ATP Handbook

ATP Handbook: Annex 1, Appendix 2, paragraph 1.2

Transmitted by the governments of Germany and United Kingdom

Figure 3

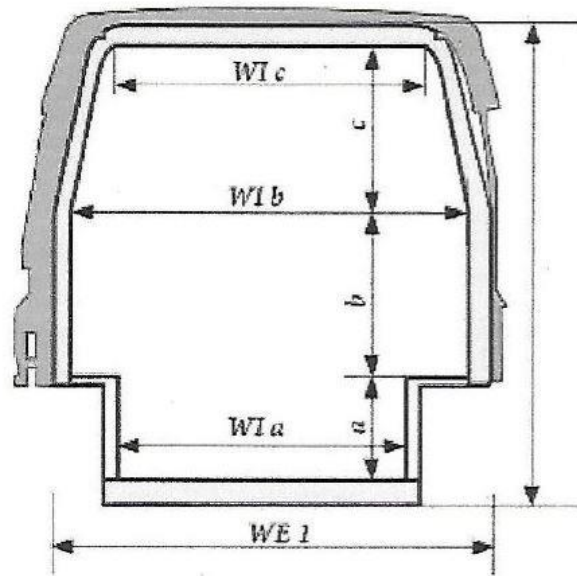
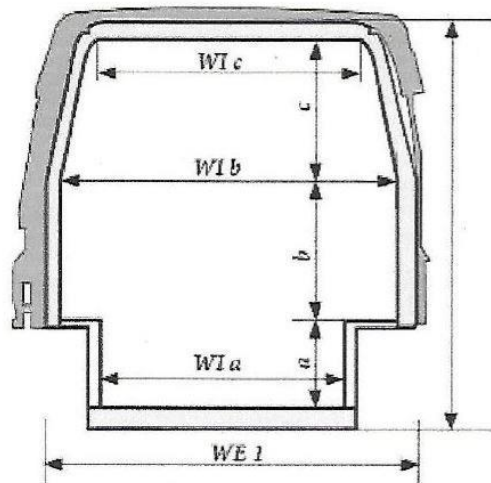
1. At the seventy-first session of WP.11 the United Kingdom submitted a revised proposal to harmonise the external surface area measurements of panel vans and test reports (ECE/TRANS/WP.11/2015/2), this was adopted.
2. At last year's seventy-third session of WP.11 the proposal was published in the latest ATP agreement dated 6 January 2018. Subsequently at the latest CERTE meeting in Germany it was noted that the equations were different compared to the CEN standard, these corrections to the equations are to harmonise the ATP and CEN standards.
3. Germany and the United Kingdom propose to amend the figures in paragraph 1.2 in the ATP handbook with the following:

$$WE = WI + \text{mean declared thicknesses}$$

$$WI = \frac{((Wl_{bx}b) + (Wl_{bx}c) - ((Wl_b - Wl_c) \times c) + (Wl_{bx}a) + (2 \times ((Wl_b - Wl_a) \times a)))}{(a + b + c)}$$

$$W_E = W_I + \text{declared mean thickness} \times 2$$

$$W_I = \frac{W_{Ia} \times a + W_{Ib} \times b + \frac{W_{Ib} + W_{Ic}}{2} \times c}{a + b + c}$$

Figure 4

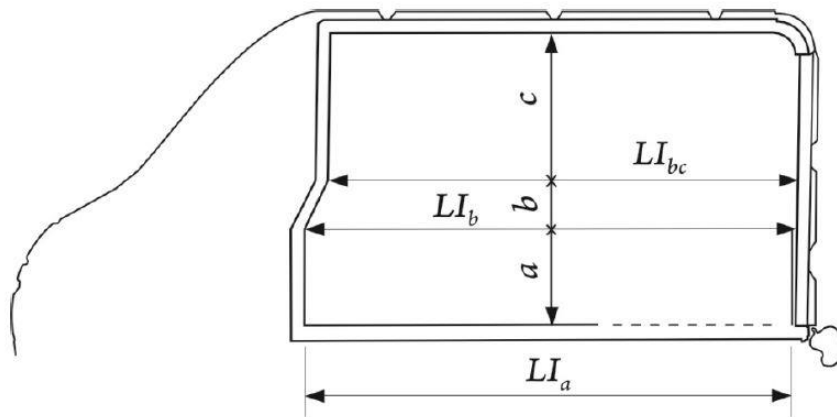
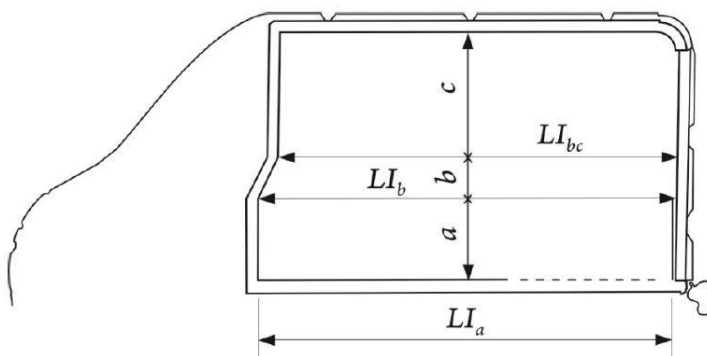
$$LI = \frac{(LI_a \times a) + (LI_b + LI_c) / 2 \times b + (LI_c \times c)}{a + b + c}$$

$$LE = LI + \text{mean declared thicknesses}$$

$$L_I = \frac{(L_{Ia} \times a) + (L_{Ib} + L_{Ic})/2 \times b + (L_{Ic} \times c)}{a + b + c}$$

$$L_E = L_I + \text{declared mean thickness} \times 2$$

Figure 5

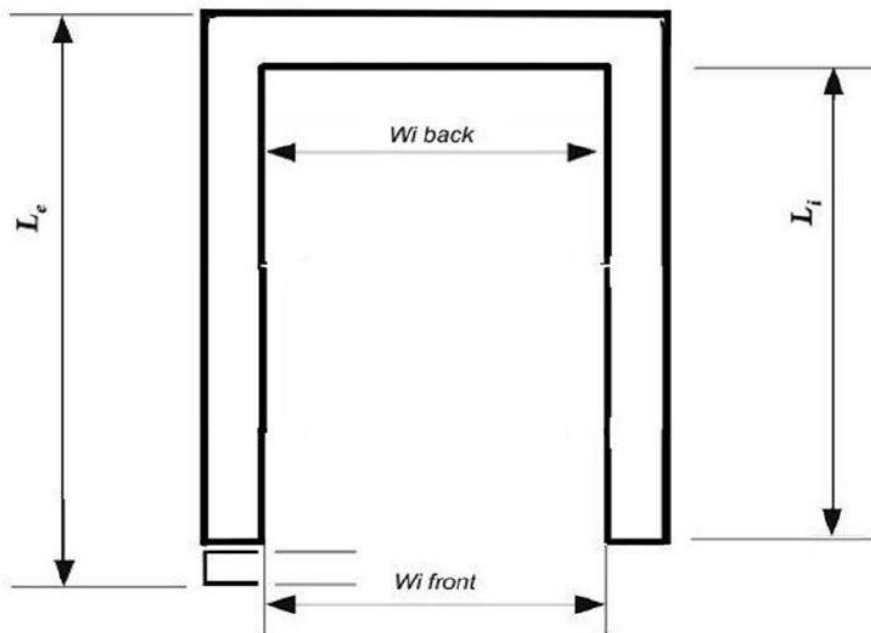
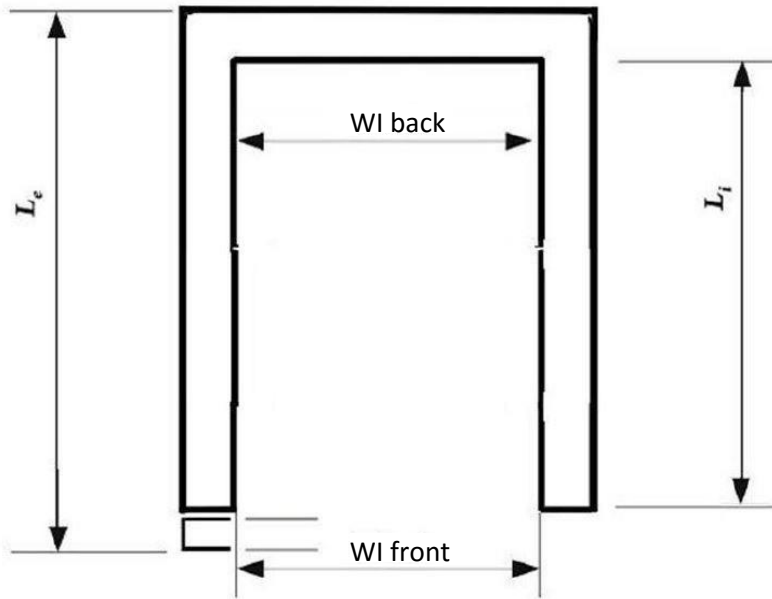
$$Wi = \frac{(Wi \text{ back} + Wi \text{ front})}{2}$$

$$We = Wi + \text{mean declared thickness}$$

$$WI = \frac{WI\ back + WI\ front}{2}$$

$$WE = WI + \text{mean declared thickness} \times 2$$
